# City of Rialto

File #: TC 21-0802, Version: 1

### **Traffic Impact Analysis - Foothill Apartment TIA - 534 Foothill Boulevard (ACTION ITEM)**

**Exhibit 4.12 - Street Section**

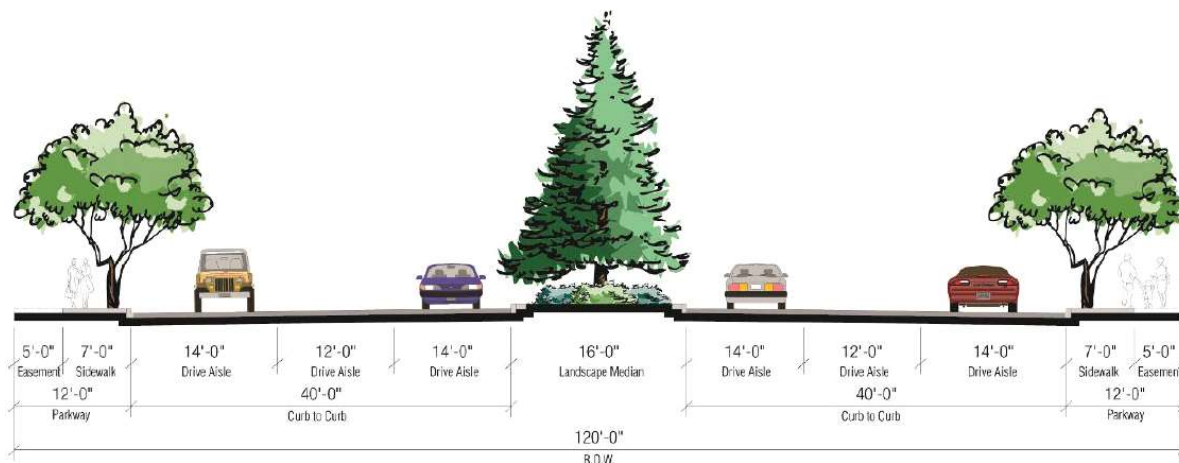
In addition to access configuration, it is recommended that the Project construct Foothill Boulevard at its ultimate half-width as a Modified Major Arterial I (120-foot right-of-way) from the western Project boundary to the eastern Project boundary consistent with the City's standards. This will meet the requirements of the Foothill Boulevard Specific Plan as shown below:
